Access Compliance Report

Public Rights-of-Way

(Curb Ramps)

Intersection ID: 3474	Main Street: W W T HARRIS BV	Cross Street: W WT HARRIS TO I-77 RA NB	Location: S
ADA ID: E46C18AAB881	Ramp Type: Para	Initial Pass/Fail: Fail	Overall Compliance: No
Codes/Mitigation Info/Possible Solution		Field Measurements/Component Compliance

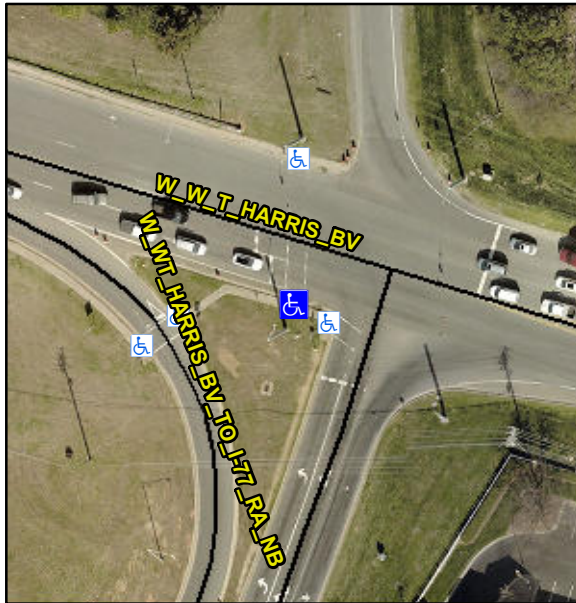
R304.5.3, R304.3.2

Compliance	Description	Data	Compliance	Description	Data
N/A	Ramp Length LT (in)	68.5	N/A	Ramp Length RT (in)	66.5
Yes	Ramp Width LT (in)	59.5	Yes	Ramp Width RT (in)	59.0
Yes	Ramp Slope LT (%)	6.5	No	Ramp Slope RT (%)	9.7
No	Ramp XSlope LT (%)	2.8	Yes	Ramp XSlope RT (%)	2.0
N/A	Landing Length (in)	N/A	N/A	DWS Provided?	N/A
N/A	Landing Width (in)	N/A	N/A	DWS Contrast?	N/A
N/A	Landing Slope (%)	N/A	N/A	DWS Length (in)	N/A
N/A	Landing X Slope (%)	N/A	N/A	DWS Full Width?	N/A
N/A	Landing Curb? (Y/N)	N/A	N/A	DWS Offset (in)	N/A
N/A	Shared Landing?	N/A			
N/A	Gutter Ponding?	N/A	N/A	Gutter Slope (%)	N/A
N/A	Gutter Lip Ht (in)	N/A	N/A	Gutter X Slope (%)	N/A
N/A	Painted X Walk1?	No	N/A	Painted X Walk2?	N/A
	X Walk 1 Direction	To N		X Walk 2 Direction	N/A
N/A	X Walk 1 Width (in)	N/A	N/A	X Walk 2 Width (in)	N/A
	X Walk 1 Slope (%)	4.0		X Walk 2 Slope (%)	N/A
	X Walk 1 X Slope (%)	0.8		X Walk 2 X Slope (%)	N/A
N/A	Ramp inside XWalk1?	N/A	N/A	Ramp inside XWalk2?	N/A

Remove & Replace Entire Ramp.
